# UNITED STATES PATENT AND TRADEMARK OFFICE

APPLICATION NO.	FILING DATE	FIRST NAMED INVENTOR	ATTORNEY DOCKET NO.	CONFIRMATION NO.
10/565,469	01/19/2006	Tobias Melz	1033832-000013	9936
21839 7590 09/12/2007 BUCHANAN, INGERSOLL & ROONEY PC POST OFFICE BOX 1404 ALEXANDRIA, VA 22313-1404			EXAMINER NGUYEN, XUAN LAN T	
			ART UNIT 3683	PAPER NUMBER
			NOTIFICATION DATE 09/12/2007	DELIVERY MODE ELECTRONIC

## Office Action Summary

## **DETAILED ACTION**

### 第 3 図

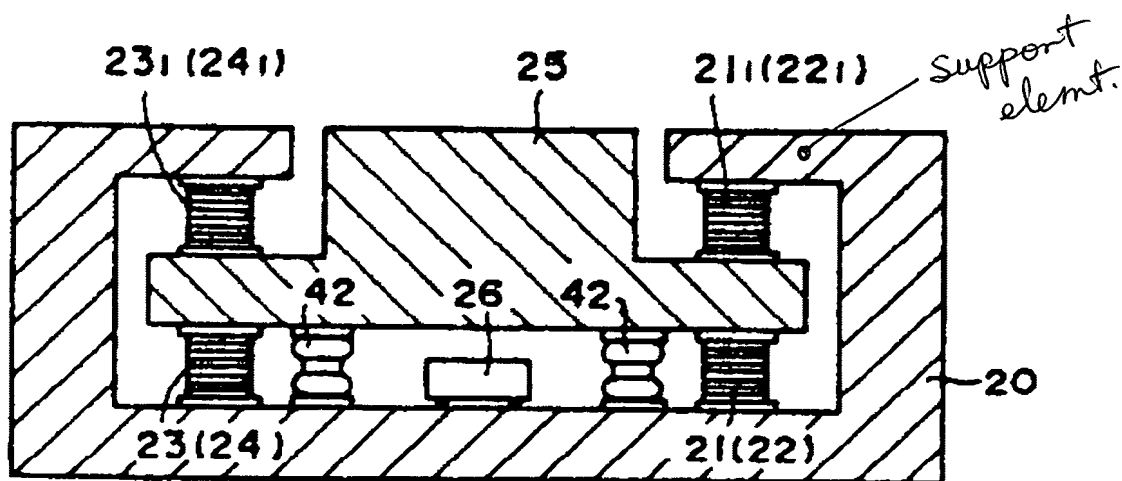
6. Claims 10, 11, 13, 15, 16, 18, 19 and 21-24 are rejected under 35 U.S.C. 103(a) as being unpatentable over Katsumi (JP 61286634) in view of Sasaki et al. (US 5,373,670).

Re: claim 10, Katsumi shows an interface for reducing mechanical vibrations, as in the present invention, which has a base connection element 20, a load connection element 25 and at least one support element, as marked below, a) wherein at least a first energy converter system, 21, 23 bottom, extends between at least one engagement point located on the base connection element and at least one engagement point located on the load connection element; b) wherein at least one second energy converter system, 21, 23 top, extends between at least one engagement point located on the support element and at least one engagement point located on the load connection element; and d) wherein the load connection element 25 has a part located in an intermediate space between the base connection element and the support element, and a part located outside the intermediate space between the base connection element and the support element, as shown in figure 3. Katsumi lacks the elastic pipe surrounding the actuators as claimed. Sasaki shows an elastic pipe 14 for a vibration damper in figure 1 in order to provide further dampening capability to the

bearing body 13 at the same time to protect body 13 from environmental elements. It would have been obvious to one of ordinary skill in the art at the time the invention was made to have modified Katsumi's assembly to comprise an elastic pipe as taught by Sasaki in order to provide further dampening capability to the assembly of Katsumi at the same time protecting the assembly from environmental elements.
